Tennessee Valley Authority, 1101 Market Street, Chattanooga, Tennessee 37402

CNL-14-228

Watts Bar Nuclear Plant Unit 1
Facility Operating License No. NPF-90
NRC Docket No. 50-390

Subject: **REQUEST FOR ADDITIONAL INFORMATION RELATED TO LICENSE AMENDMENT REQUEST TO UPDATED FINAL SAFETY ANALYSIS REPORT CHANGES ASSOCIATED WITH HYDROLOGIC ANALYSIS (TAC NO. ME9130)**

The following figure illustrates the computed API results prior to the main storm and demonstrates that runoff in the main storm is not sensitive to initial moisture conditions:

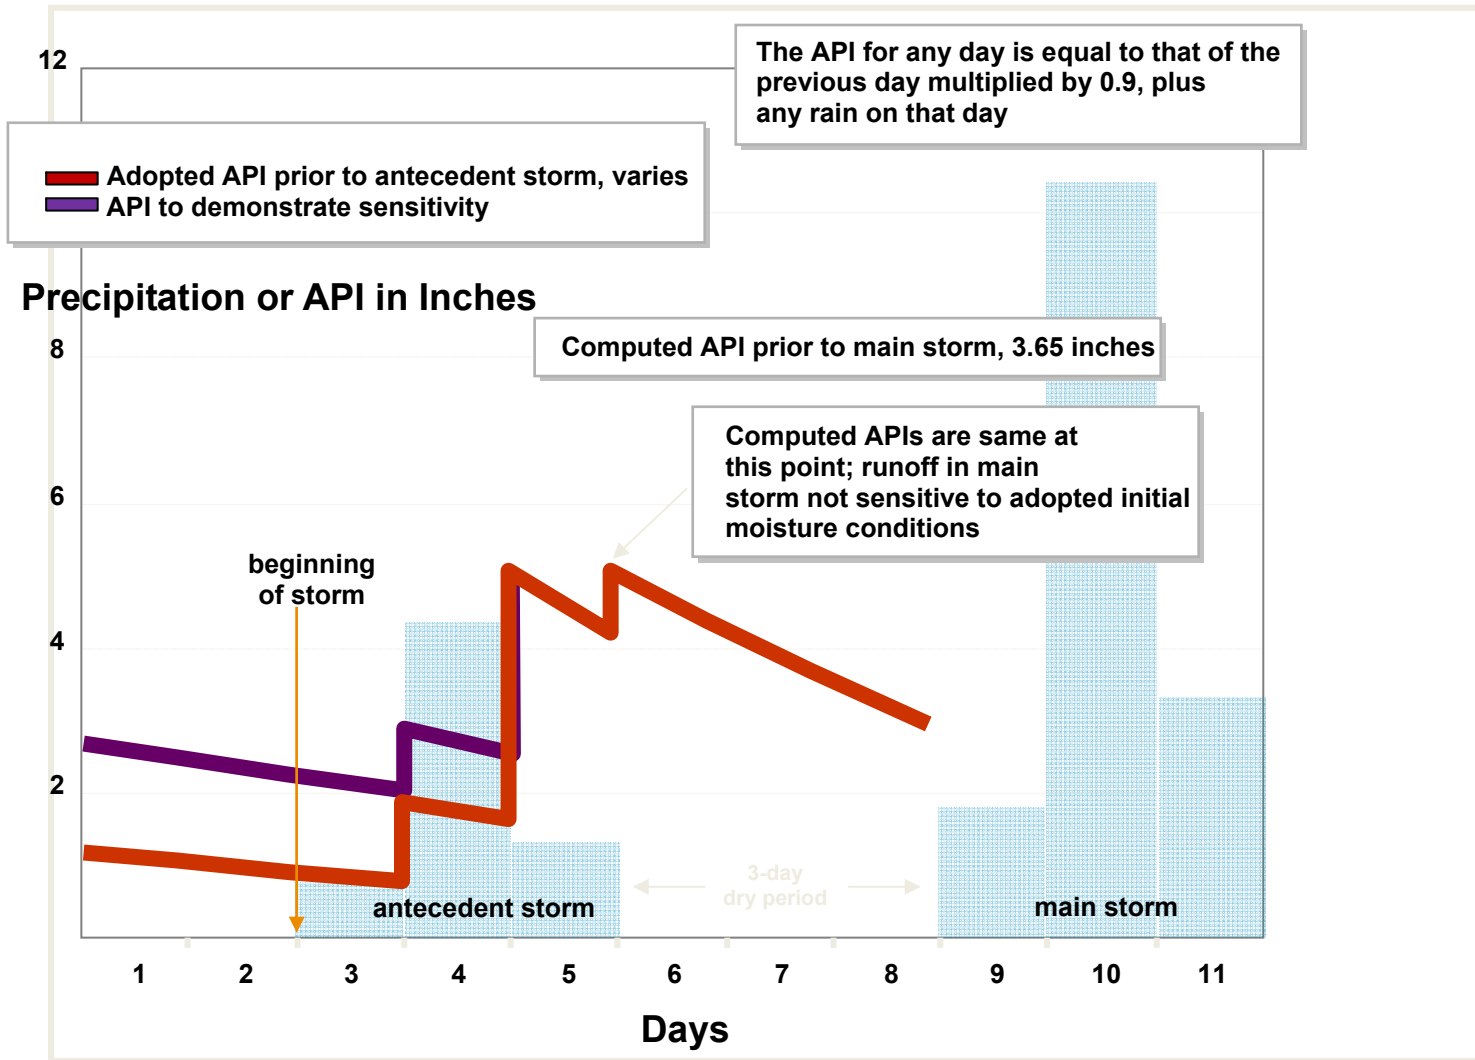
The FSAR Section 2.4.3.1 of the September 30th submittal shows the PMP depth is 16.17 inches and the antecedent depth is 6.0 inches. FSAR Section 2.4.3.1 also states that the antecedent depth is 40 percent of the total PMP depth (6.47 inches). NRC staff requests that TVA clarify and explain the apparent discrepancy between the antecedent depth 6.0 inches and 6.47 inches, which is equal to 40 percent of the PMP depth. NRC also requests that TVA clarify the antecedent depth actually used.

In Section 2.4.3.2 of September 30th 2014 submittal, TVA states that the API numerical value was determined using the observed data from 1997 to 2007. Please provide supporting documents to illustrate use of the API method and its computed numerical values, including computational examples illustrating how the excess rainfall depth showed in Table 2.4-11 were determined.

In the UFSAR, a median antecedent precipitation index (API) as determined from past records was used at the start of the antecedent storm. As described in UFSAR Section 2.4.3 of the 2012 and 2014 LAR, 1997-2007 gage data was used to determine starting API values. These values represent initial mean soil moisture conditions for each sub-basin.

The following provides an illustrative example of the API method and how the computed numerical values are determined as documented in calculation CDQ000020080052 (Reference 3) :
